Power Sliding Door 25A Fuse Open

Category Vehicle Exterior

Section Door/Hatch Market USA

YEAR(S)	MODEL(S)	ADDITIONAL INFORMATION
2011 - 2016	Sienna

Figure 4.

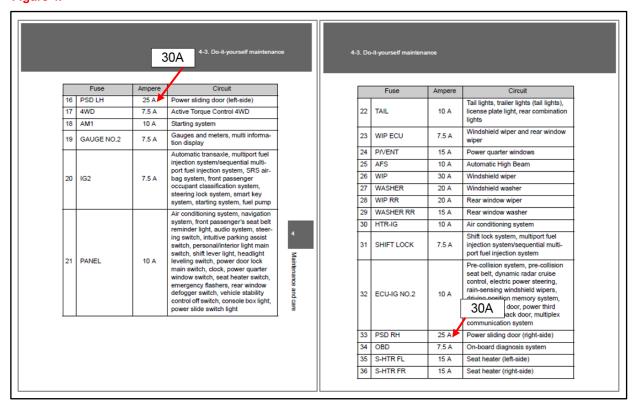
- YES Diagnose for repair for shorting circuit.
- NO This bulletin does NOT apply. Continue diagnosis using the applicable Repair Manual.
- 12. Perform Health Check using Techstream and confirm there are no DTCs present.
- 13. For 2011 2014 model year vehicles, apply the 2 fuse size stickers (30A) over the Ampere rating boxes of both PSD LH and PSD RH on the pages listed.

MODEL YEAR	PAGES REQUIRING UPDATE
2011	657, 658
2012	706, 707
2013	722, 723
2014	721, 722
